Re: Clean Air Coalition Comment on Site Number: C915196B 1001 East Delavan Avenue Site
Brownfield Cleanup- Remedial Investigation Work Plan

The Clean Air Coalition respectfully submits the following comments regarding the Remedial Investigation Work Plan for Site Number C915196B: Brownfield Cleanup at the site formerly known as GM/American Axle and Manufacturing (GM/AAM), currently owned by East Delavan Properties (EDP).

Clean Air Coalition retained New York State Professional Geological Services, PLLC (nygeology) to assist with the technical review of the Inventum Engineering (Inventum) Remedial Investigation Work Plan (RI and RIWP respectively) for the American Axle Brownfield Cleanup Program (BCP) Site. Comments prepared by nygeology are presented below.

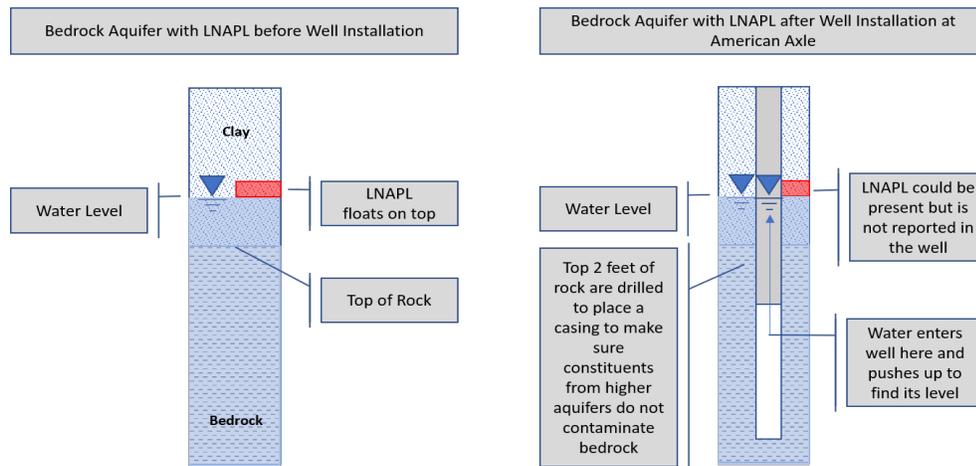
General: The RIWP assumes LNAPL data from historic bedrock wells to be accurate and generally unchanging spatially.

Analysis: Spatial stability of LNAPL is known to occur following source removal. Construction data from the logs of the historic bedrock wells referenced in the RIWP suggest that LNAPL measurements in these wells may not accurately reflect site conditions. Since LNAPL tends to float on water, wells must be open to the formation to be able to examine the surface of the water. Historic bedrock well construction at the BCP Site followed the conventional site investigation procedure of casing off the overburden and incompetent rock surface as normally used to test for dissolved constituents at depth. However, at the BCP Site, the potentiometric surface of water in bedrock was much higher than the open part of the well, as illustrated below:

As shown above, LNAPL collecting above bedrock cannot enter the well since the part of the well open to the formation is too deep. Well data from wells with logs and water level data included in the RIWP is presented below:

Requested RIWP Revisions: Refer to specific comments made herein to the RIWP Section 5 BCP Remedial Investigation Scope of Work.
